**ZONING AMENDMENT,
& SUBDIVISION STAFF REPORT****Date: June 7, 2007****APPLICANT NAME**

SUBDIVISION NAMEKnippers First Addition to Mobile Subdivision,
Resubdivision of Lots 7 & 8**LOCATION**2600 and 2602 St. Stephens Road
(Northeast corner of St. Stephens Road and Reynolds
Avenue)**CITY COUNCIL
DISTRICT**

REQUEST Subdivision, Rezoning from R-1 to LB-2

SITE PLAN

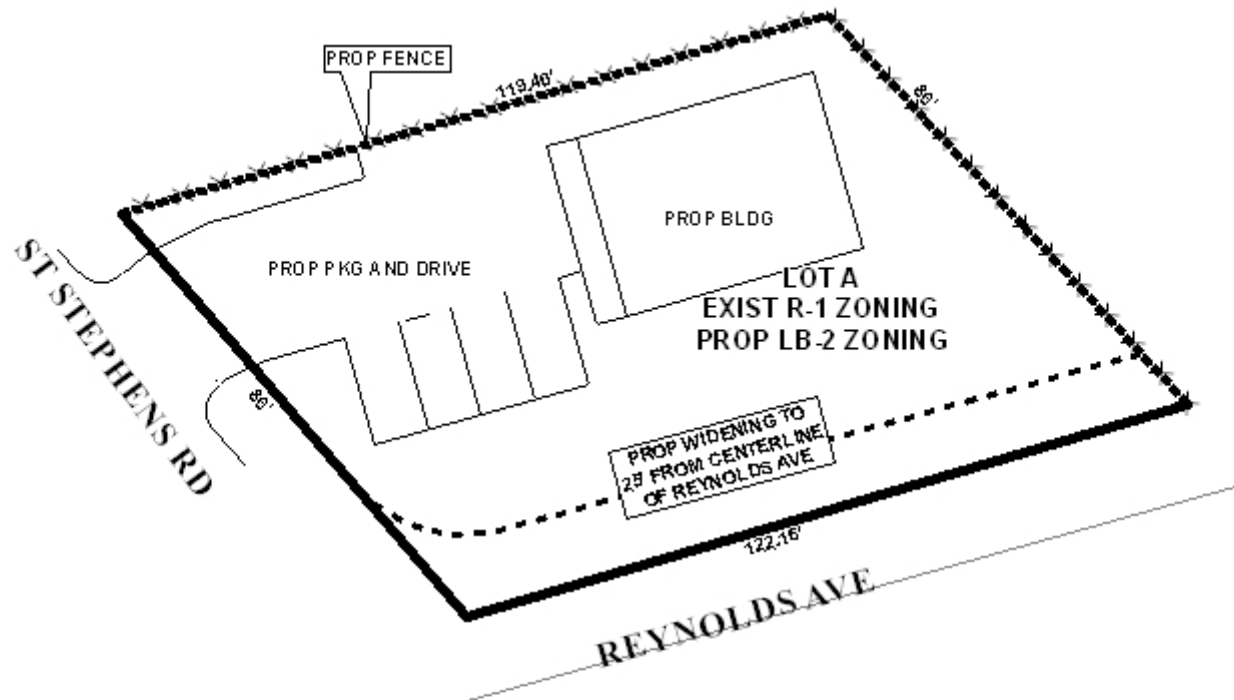
Conveyance of a commercial zoning designation to the site will require any development of the site to fully comply with the Zoning Ordinance, including the provision of paved parking, sidewalks, trees and landscaping, residential adjacency buffers, and site lighting. The site plan provided as part of the application shows the minimum number of required parking spaces for the proposed use, but does not show the required landscaping or an adequate residential adjacency buffer: the building should be at least ten (10) feet from the side and rear property lines where it abuts residentially zoned property.

Regarding the minimum building setback lines, Section V.D.9. of the Subdivision Regulations requires a 25-foot minimum building setback from the right-of-way, while Section 64-4.D.3. of the Zoning Ordinance allows side yards with street frontage to be 20 feet in width, as depicted on

the Subdivision plat along Reynolds Avenue. As the proposed development will front St. Stephens Road, the 25-foot minimum building setback line along Reynolds Avenue may be waived in favor of the side yard setback required by the Zoning Ordinance.

St. Stephens Road is part of the US Highway system, thus it is under the purview of ALDOT. It is recommended that the site be limited to one curb-cut onto St. Stephens Road and denied access onto Reynolds Avenue. The size, design and location of the curb-cut must be approved by ALDOT and Traffic Engineering and conform to AASHTO standards. .

- 1) placement of a note on the final plat stating that the site is limited to one curb-cut onto St. Stephens Road and denied access to Reynolds Avenue, with the size, design and location of the curb-cut to be approved by ALDOT and Traffic Engineering, and conform to AASHTO standards;

- 2) dedication of right-of-way sufficient to provide a 50-foot wide right-of-way for St. Stephens Road, as measured from the centerline, and 25-foot wide right-of-way for Reynolds Avenue, as measured from the centerline, and adjustment of the minimum building setback lines to reflect the dedications;

- 3) revision of the Subdivision plat to reflect the minimum building setbacks as required by the Zoning Ordinance, with the Reynolds Avenue side considered a side yard;

- 4) revision of the plat to label the lot size, less dedication, in square feet; and
- 5) full compliance with all other municipal codes and ordinances.
